# SERVICE BULLETIN 176E

March 3, 2003

**SUBJECT:** Necessary Actions Following Object Strike of Stationary Propeller, Blade Strike of Rotating Propeller, Bird Strike, or Sudden Engine Stoppage

**MODELS AFFECTED:** All McCauley Propellers

Figure 1

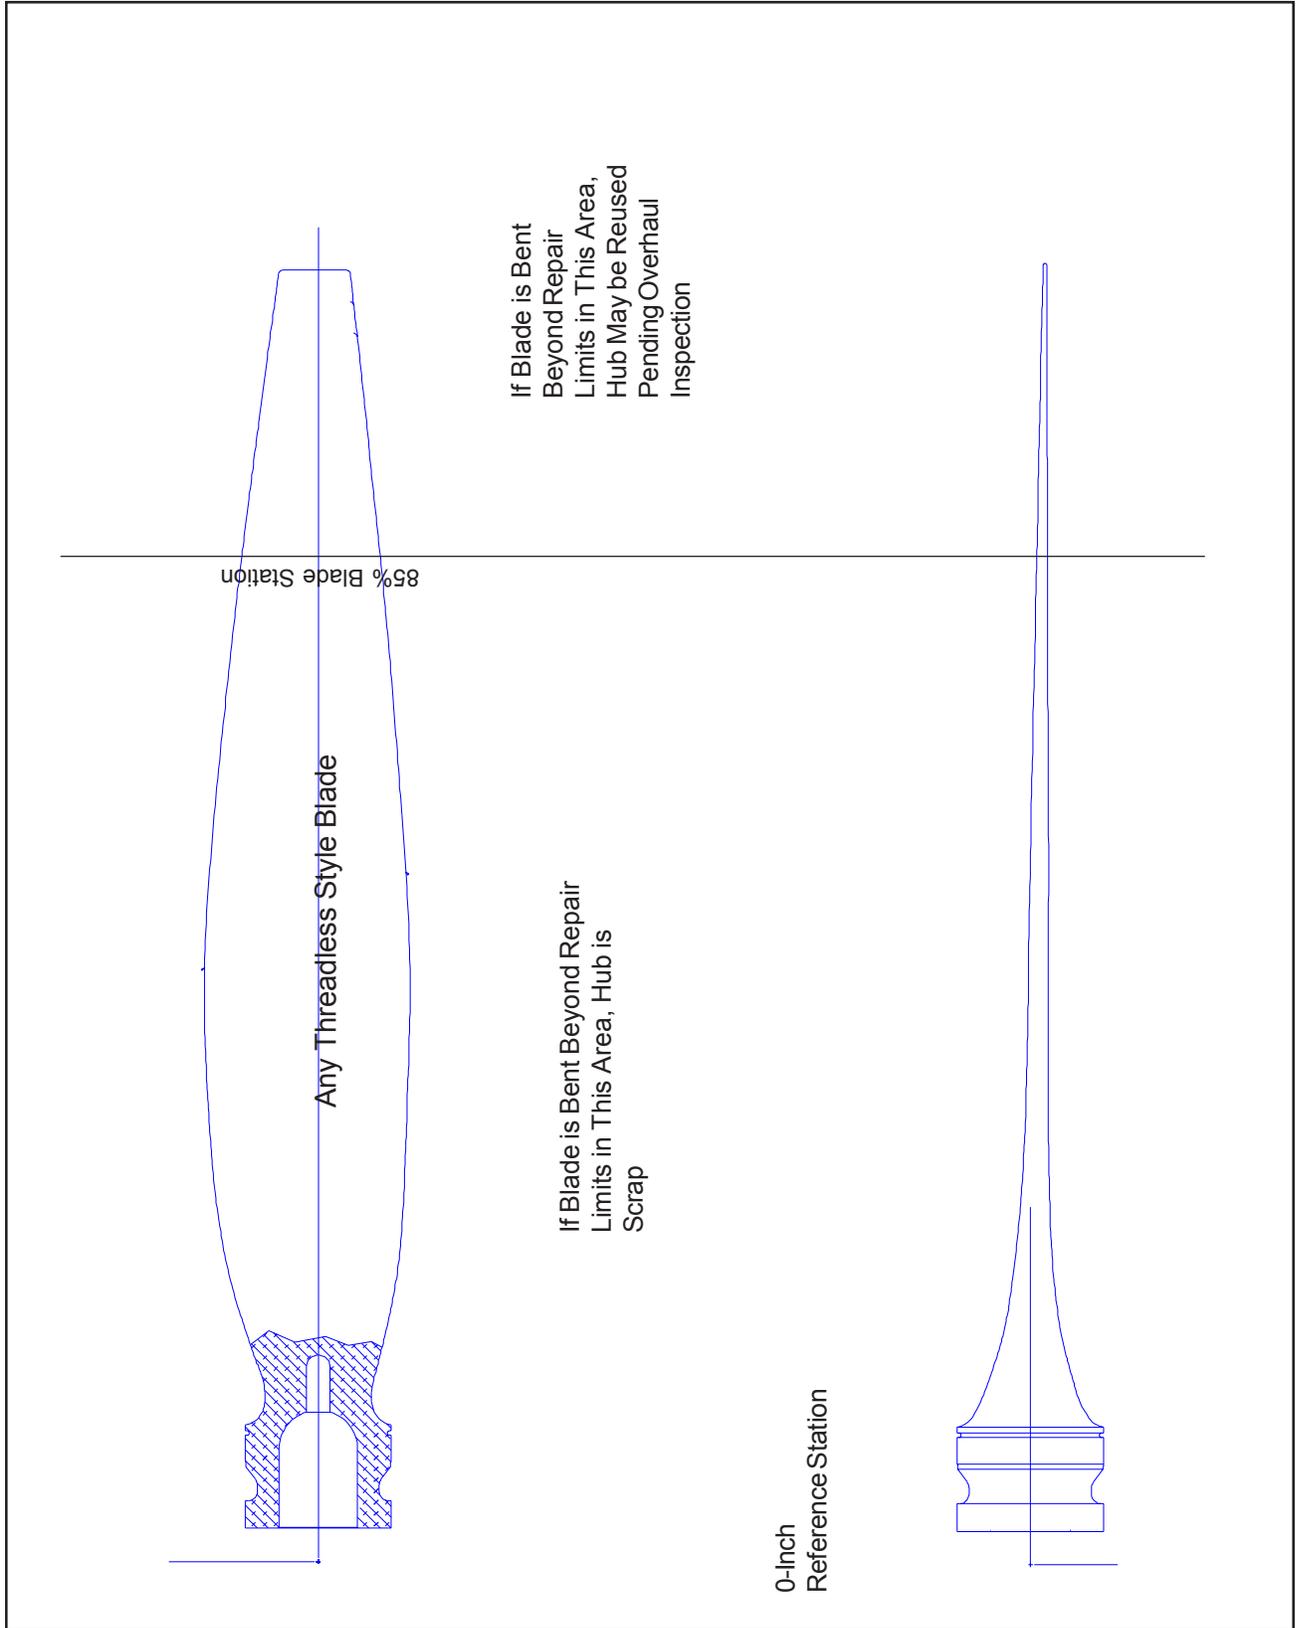
A hub must be declared unairworthy and scrapped if any blade in the propeller assembly is bent beyond repair limits within the first 85% of total blade station radius (Refer to Figure 1 and 2). A hub may be returned to service, pending normal overhaul inspection, if any blade in the propeller assembly is bent beyond repair limits outboard of the 85% blade station radius.
